UNITED STATES PATENT AND TRADEMARK OFFICE

APPLICATION NO.	FILING DATE	FIRST NAMED INVENTOR	ATTORNEY DOCKET NO.	CONFIRMATION NO.
09/987,982	11/16/2001	Chikashi Satou	110811	8001

Office Action Summary

FIG. 2
RELATED ART

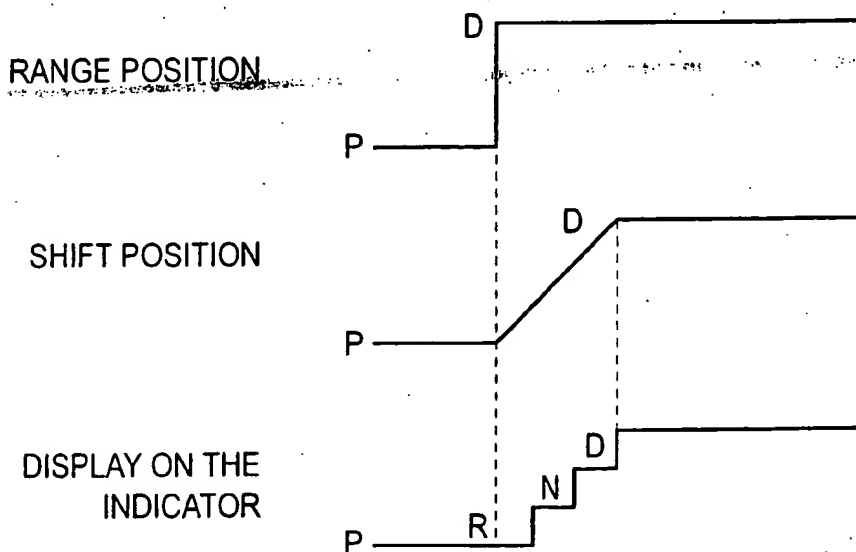
1. Figure 2 should be designated by a legend such as --Prior Art-- because only that which is old is illustrated. See MPEP § 608.02(g). Corrected drawings in compliance with 37 CFR 1.121(d) are required in reply to the Office action to avoid abandonment of the application. The replacement sheet(s) should be labeled "Replacement Sheet" in the page header (as per 37 CFR 1.121(d)) so as not to obstruct any portion of the drawing figures. If the changes are not accepted by the examiner, the applicant will be notified and informed of any required corrective action in the next Office action. The objection to the drawings will not be held in abeyance.
2. The proposed drawing correction of figure 2 was received on 4/25/05. This correction is not approved since the term "related" is not synonymous with "prior."

NOT
approved
XLN 7/11/05
